NOAA FORM 76-35A	
U.S. DEPARTMENT OF COMMERCE NATIONAL OCEANIC AND ATMOSPHERIC ADMINISTRATION NATIONAL OCEAN SERVICE	
DESCRIPTIVE REPORT	
Type of Survey	Hydrographic
Field No.	RA-10-16-95
Registry No.	H-10639
LOCALITY	
State	Alaska
General Locality	Prince William Sound
Sublocality	Northern Portion of Cochrane Bay
19 95	
CHIEF OF PARTY CAPT Dean R. Seidel, NOAA	
LIBRARY & ARCHIVES	
DATE	APR 0 1997

HYDROGRAPHIC TITLE SHEET

Locality Northern Portion of Cochrane Bay

EVALUATION REPORT

15th Ed., Sept 1990
16705

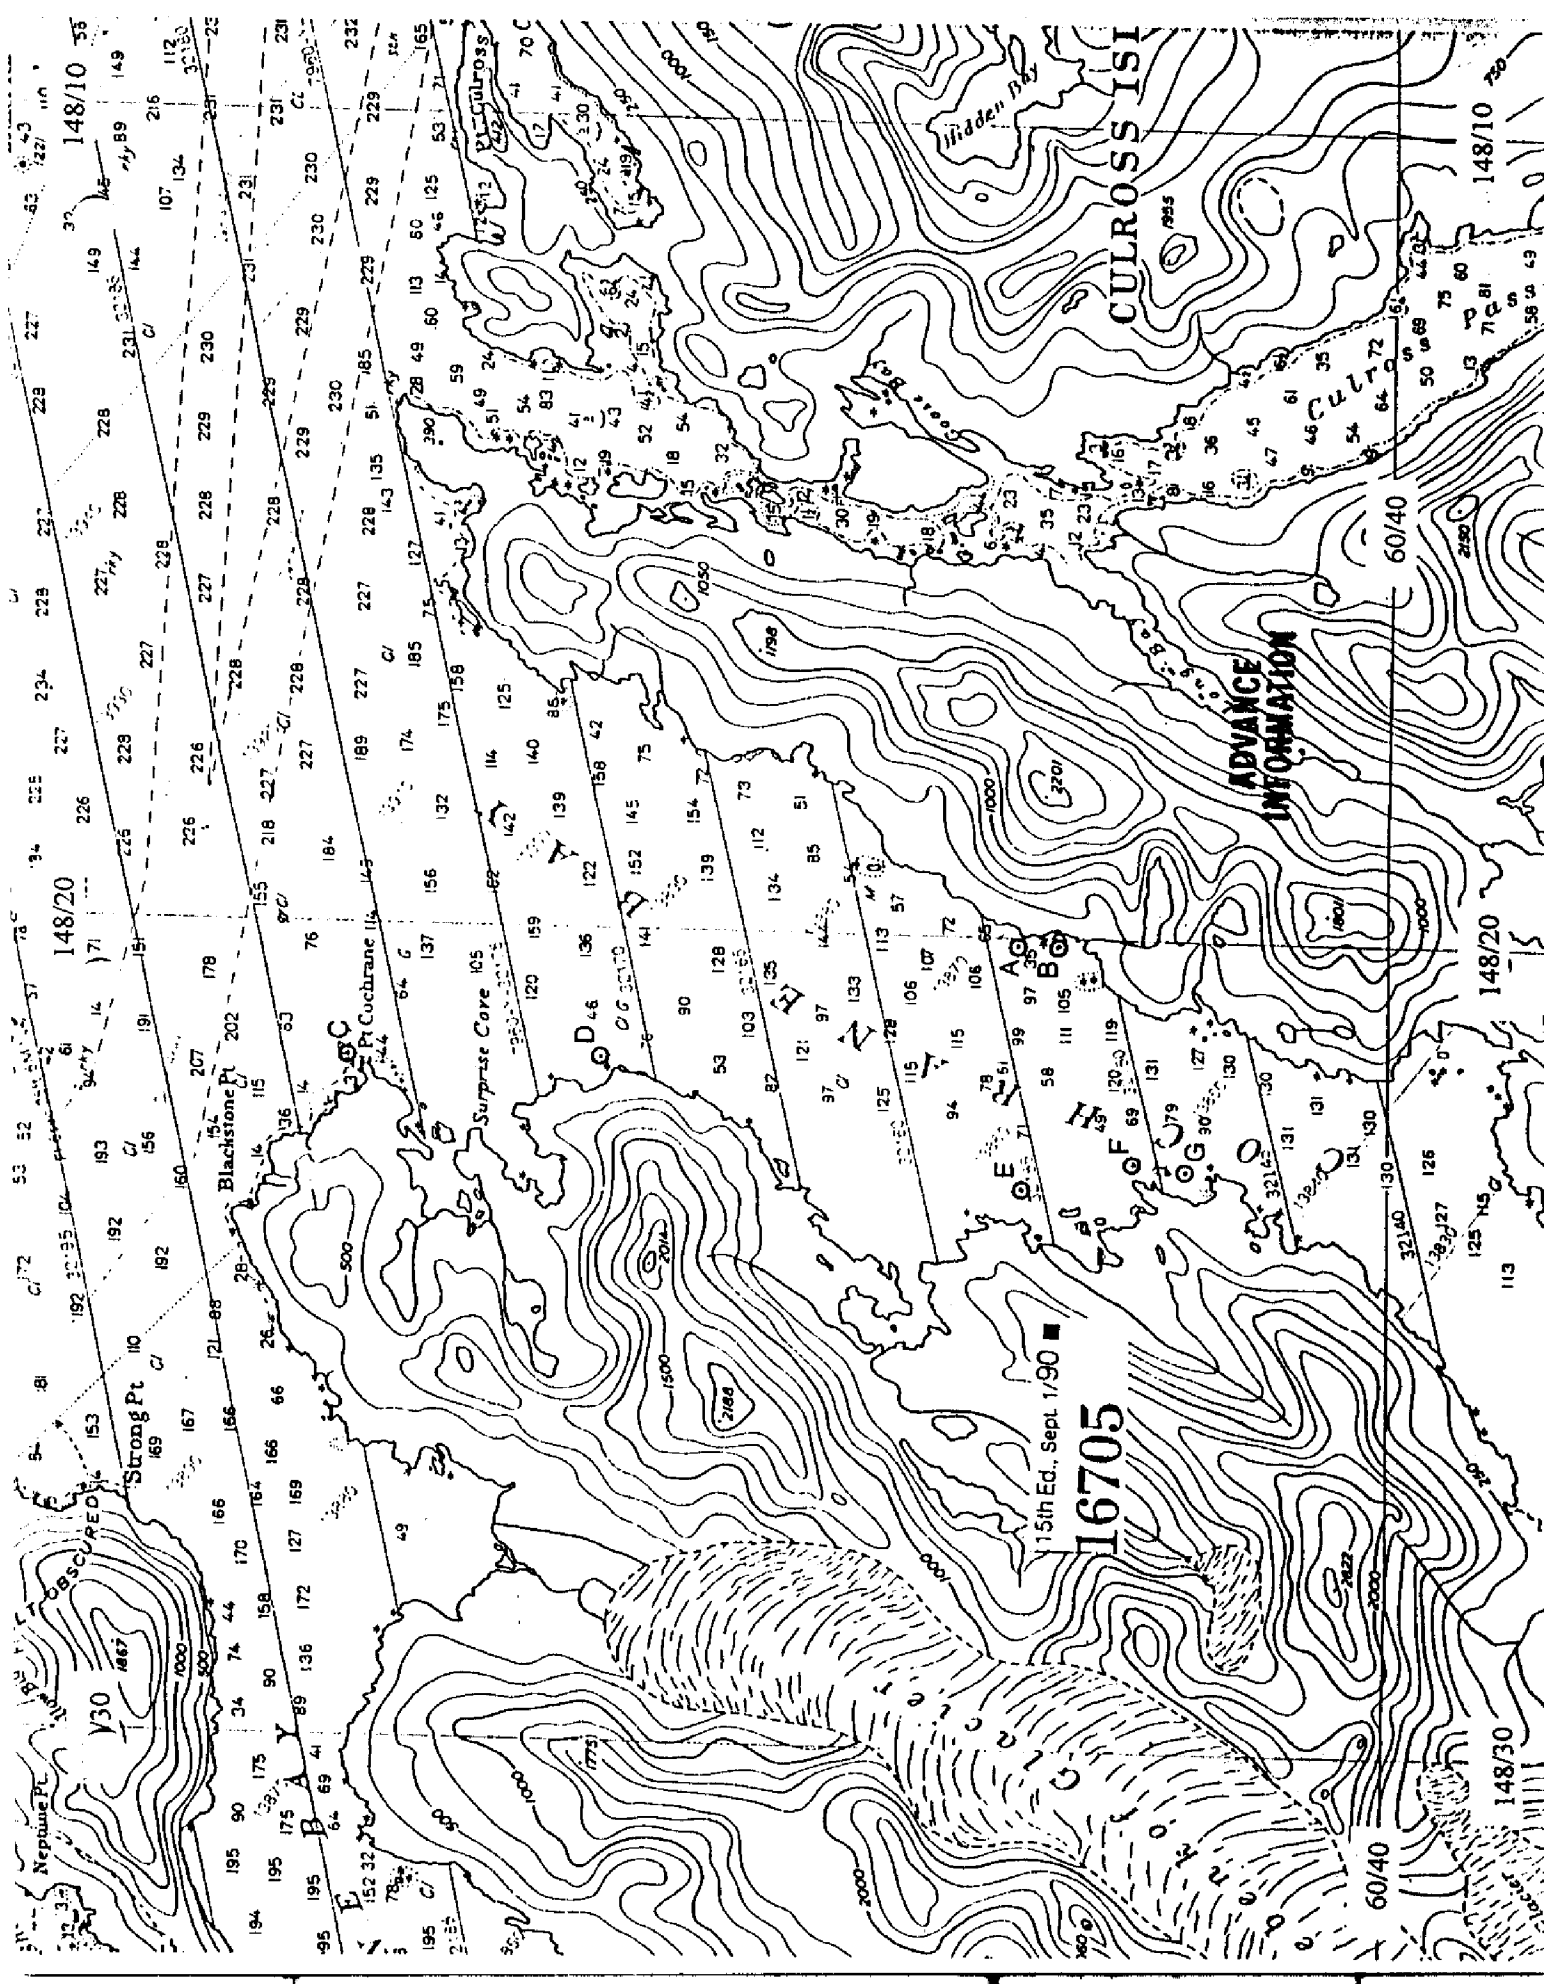
NOAA SHIP RAINIER HAS LOCATED 7 DANGERS TO NAVIGATION IN NORTHWESTERN PRINCE WILLIAM SOUND, ALASKA (PROJECT OPR-P125-RA) WITHIN THE LIMITS OF HYDROGRAPHIC SURVEY H-10639. THE FOLLOWING INFORMATION IS PROVIDED FOR PUBLICATION IN LOCAL NOTICE TO MARINERS:

ITEM	DANGER	DEPTH	LATITUDE	LONGITUDE
A.	SHOAL	COVERS 5 FMS	60/42/06.8N	148/20/07.1W 1544+1 9.6
B.	REEF	UNCOVERS 4 FT	60/41/53.6N	148/20/04.9W 1029+0 -1.1
C.*	SHOAL	COVERS 4 1/4 FMS(4 1/2)	60/41/52.4N	148/20/06.9W 1030+0 -1.1
D.*	SHOAL	COVERS 2 1/4 FMS(2 3/4)	60/46/05.4N	148/21/43.6W 2064+4 8.1
E.*	SHOAL	COVERS 7 1/4 FMS(7 1/2)	60/44/36.7N	148/21/36.5W 8304+1 4.5
F.*	SHOAL	COVERS 2 1/2 FMS(2 3/4)	60/42/05.1N	148/23/08.5W 1917+5 13.3
G.*	LEDGE ROCK	UNCOVERS 2 FT	60/41/25.6N	148/22/50.5W 1230+1 4.7
			60/41/07.9N	148/22/55.5W 1173+0 -0.5

* Items C and D cannot be shown at chart scale due to the ledge features near these soundings.
 Items E, F and G have been revised to reflect approved tides and final graphic depiction on smooth sheet.
